Subject: Information on the Replacement of Left Front Accelerometer

Brand:	Model:	Model Year:		VIN:		En- gine:	Transmis- sion:
		from	to	from	to		
Cadillac	Escalade Mod- els	2021	2023				
Chevro- let	Suburban						
	Tahoe Models						
GMC	Yukon Models

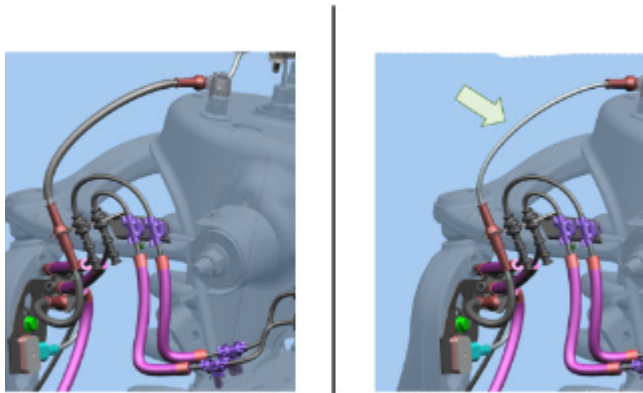
If you encounter a vehicle with a concern that leads to the replacement of the left front Electronic Suspension Wheel Front Vertical Accelerometer (Part Number 84842005), It will be necessary to remove the conduit between strut stud clip and combo bracket grommets like shown in the above illustration.

Do not replace the left front Electronic Suspension Wheel Front Vertical Accelerometer for this condition.
